August 25, 2025  
W.O. No. 2024-3776

**Re: Legacy Ridge West – A Residential Subdivision (2014.PL0003)  
Reasonable Use Exception – Response to Comments from July 7, 2025**

**TECHNICAL MEMORANDUM**

**Subject:** Review of Updated Grading Plans

**SHEET C4.0**  
 JOB NUMBER  
**24-3776**

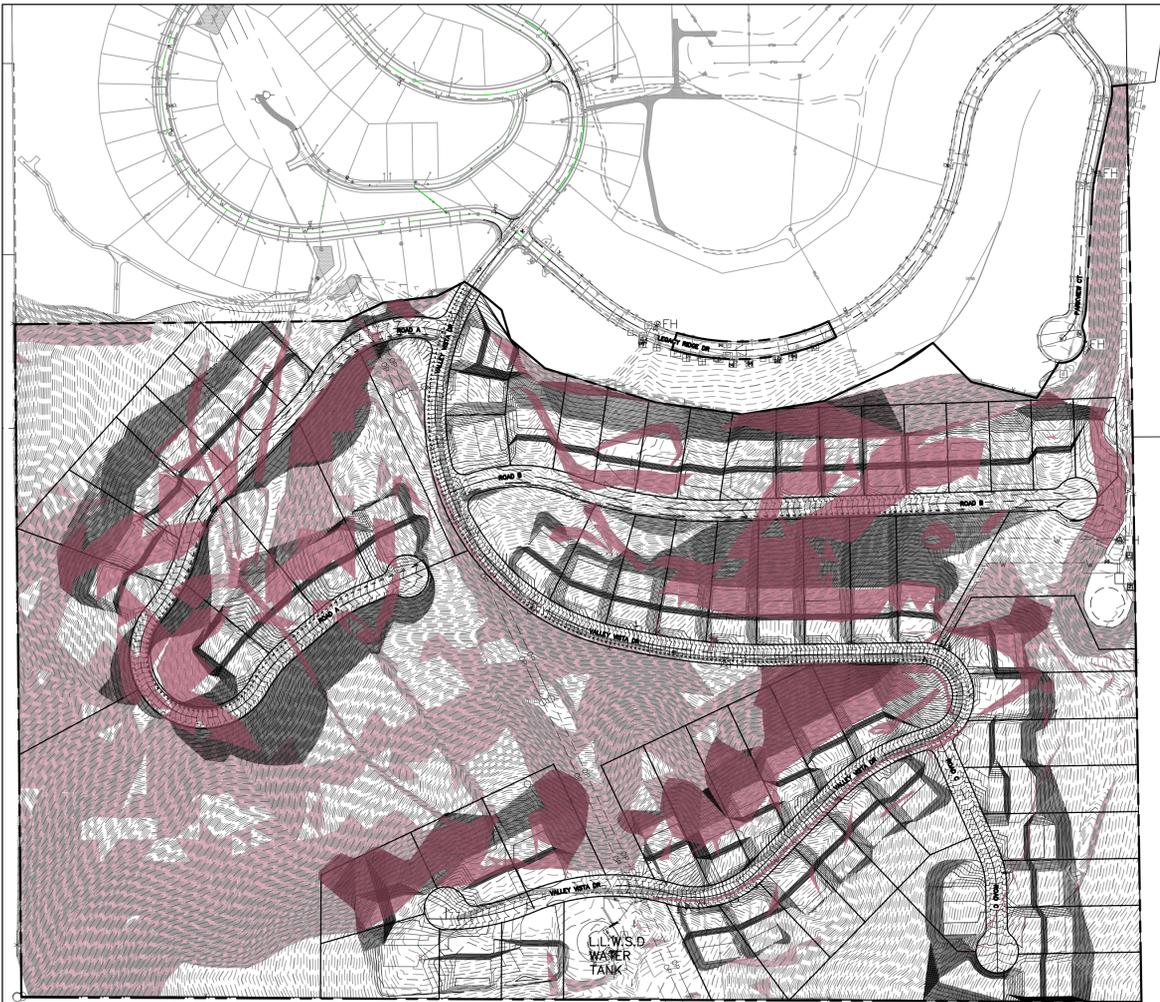
- The current plans show the roadway profile grades steeper than the City's design standards (8.0%) in many locations. The plans should be modified to our current standards to show accurately what grading will be required in the geohazard areas. If grades or any other design standards cannot be met, it should be discussed and justified in the RUE request.

**Upon receipt of this comment, we revised all new roadway profiles to no more than 8.0-percent slope, see grading plans attached. Since this comment post dated the response letter we received from Budinger, attached, we sent the revised grading plans to Budinger to see if it would materially change their report, the response is attached, but Budinger states no change to the updated report. It should be noted that Valley Vista Drive was approved and installed in a previous time in order to install water and sewer. The slope on this roadway will not be changed and since it was a previously approved plan, no design deviation is included.**

ROAD A PROFILE (STA. 0+00 TO 10+00)

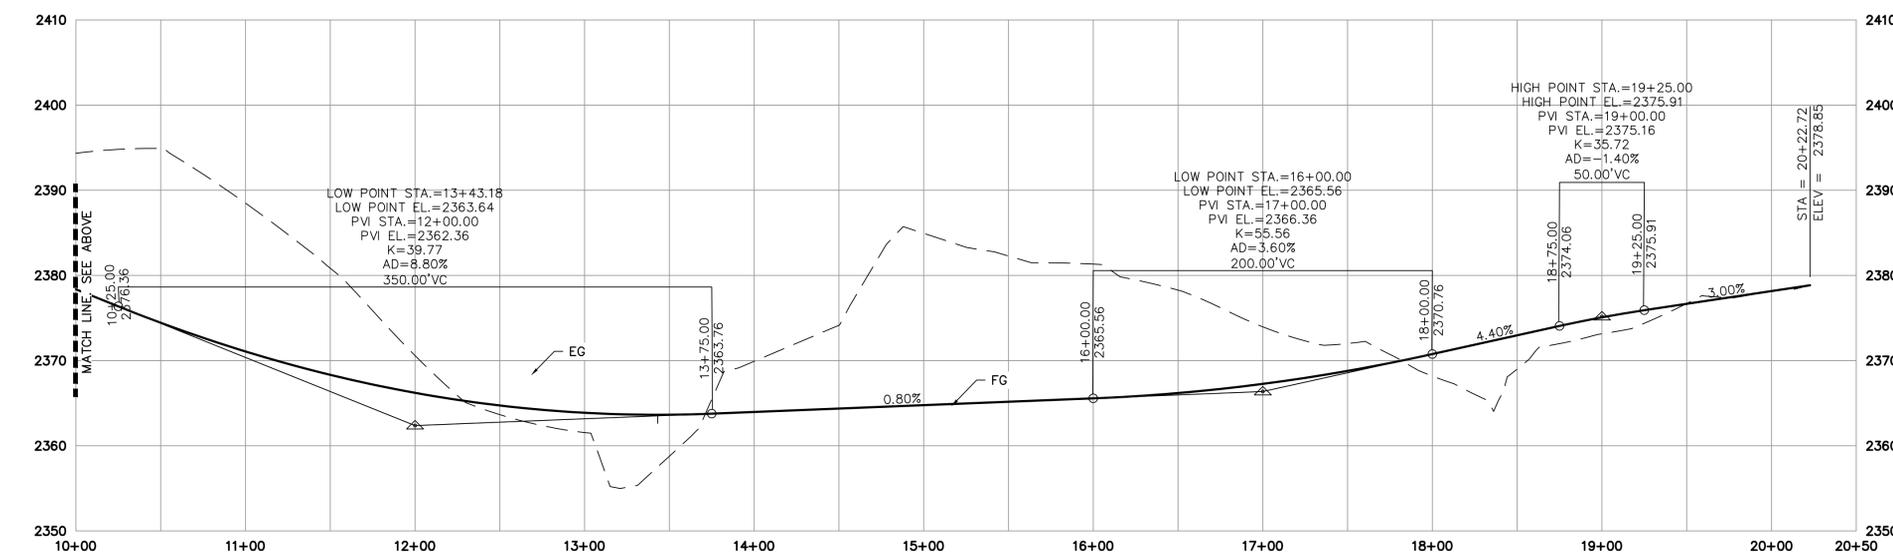
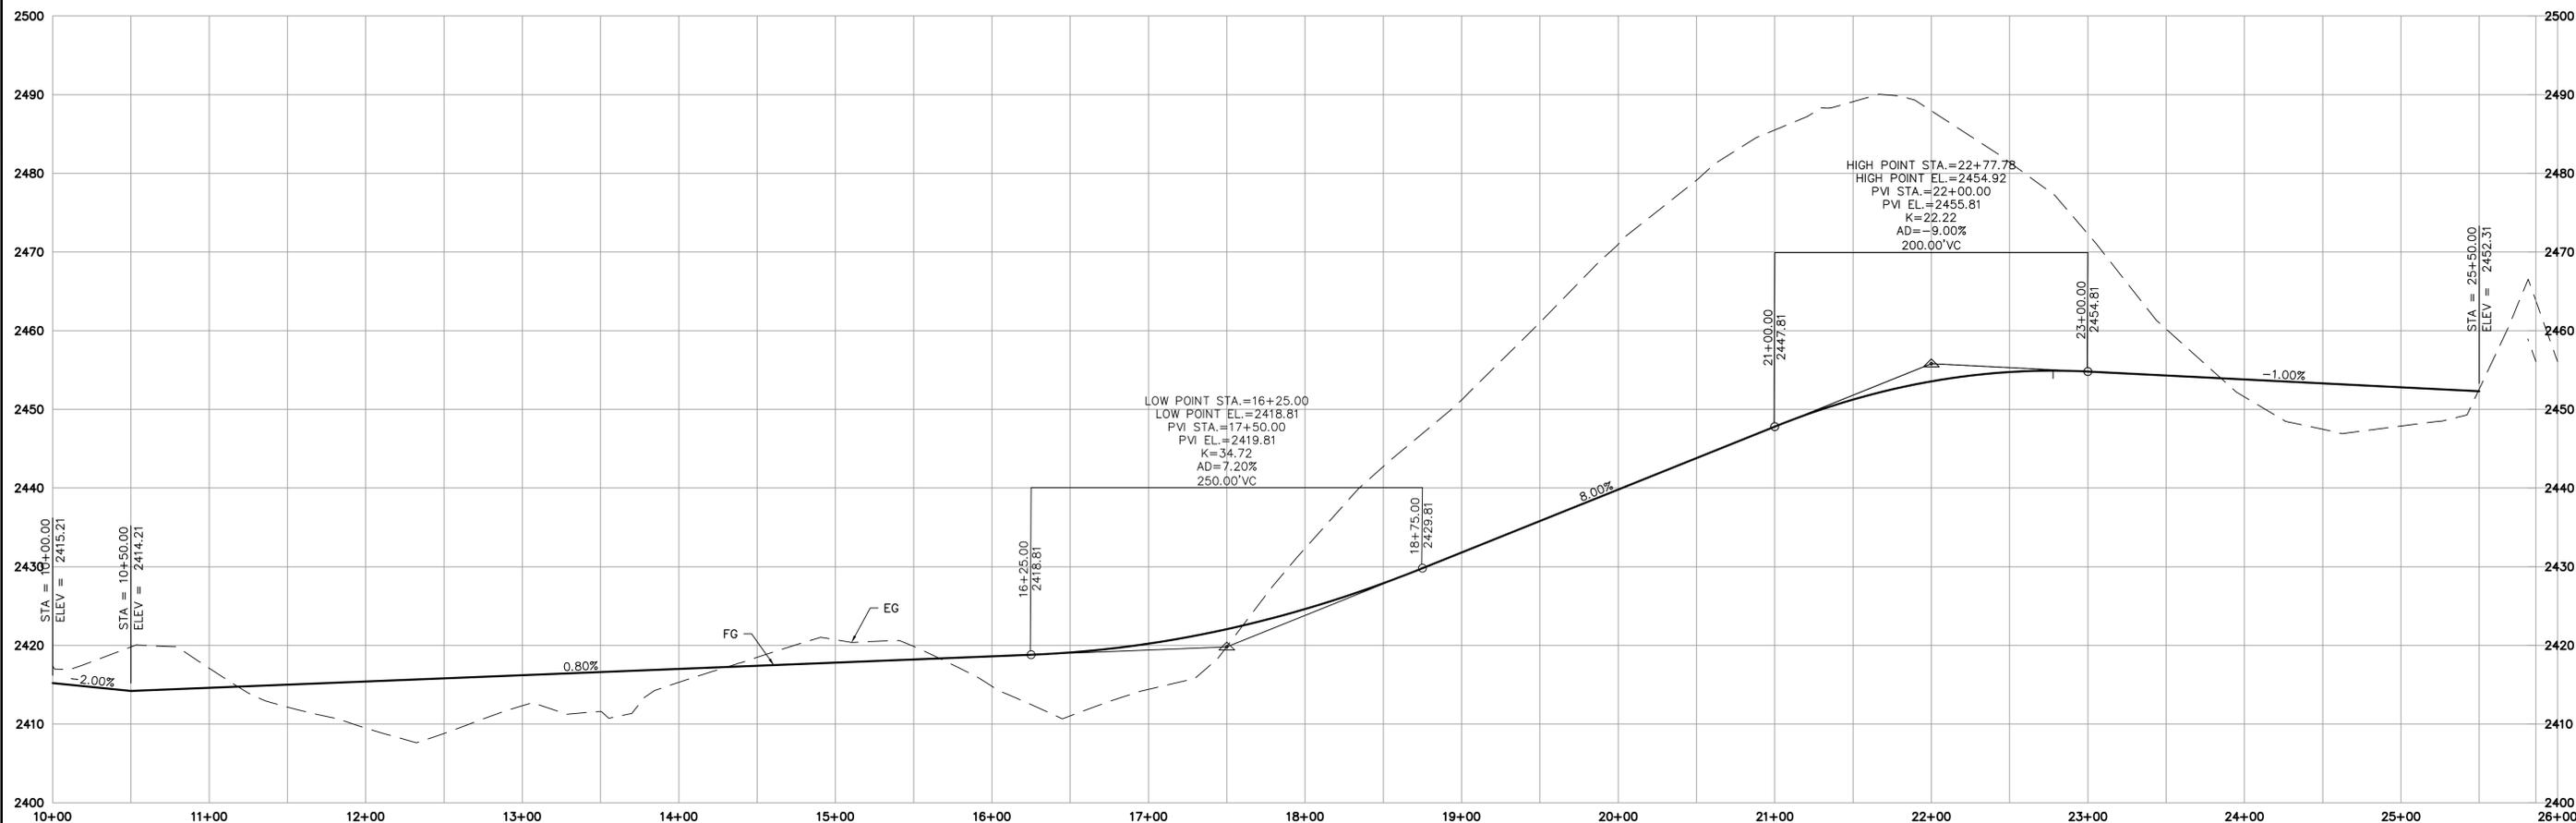
- The current plans show the roadway profile grades steeper than the City's design standards (8.0%) in many locations. The plans should be modified to our current standards to show accurately what grading will be required in the geohazard areas. If grades or any other design standards cannot be met, it should be discussed and justified in the RUE request.

Rikki, good morning. I made some revisions to the grading plan by reducing some of the roads that had a 10% grade to an 8% grade per City comment. This changed the grading some in these areas, this does **not** include Valley Vista Dr as that road is existing and has utilities in it. Please review the attached grading plans and respond back if the memorandum you previously sent dated 7/24/25 is still satisfactory or if Budinger thinks a revised memorandum is warranted, please update as necessary. Let me know if you have any questions or need anything else. Thanks.
